Work Order ID 91182

Item Name: Crosstube Turning Detail

WORK ORDER NON-CONFORMANCE / UPDATE

DART AEROSPACE LTD	Work Order:	91182
Description: Crosstube Assembly (AS350/355 High Aft)	Part Number:	D350-748-241
Inspection Dwg: D350-748-241 Rev: F		Page 1 of 2

D350-748-24

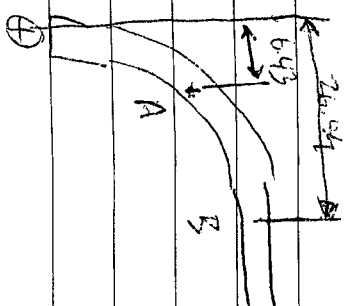
O.D. is 0.006' under in
area at lower bend. Compare
strength of that section with
the allowable near support is

$$I_A = \frac{\pi}{64} (2.228^4 - 2^4)$$

$$I_B = \frac{\pi}{64} (2.249^4 - 2^4)$$

$$F = \frac{M}{I} = \frac{P \cdot d \cdot c}{I}$$

$$M.S. = F_B / F_A - 1 \rightarrow \frac{2644 \cdot \frac{2.254}{(2.249^4 - 2^4)} \cdot (2.228^4 - 2^4)}{643 \cdot 2.228 - 1} = 2.1$$

∴ Tube will fail at support before area at lower bend,
even with 0.006 reduction in O.D. D350-748-24
BIN 91182 is OK.
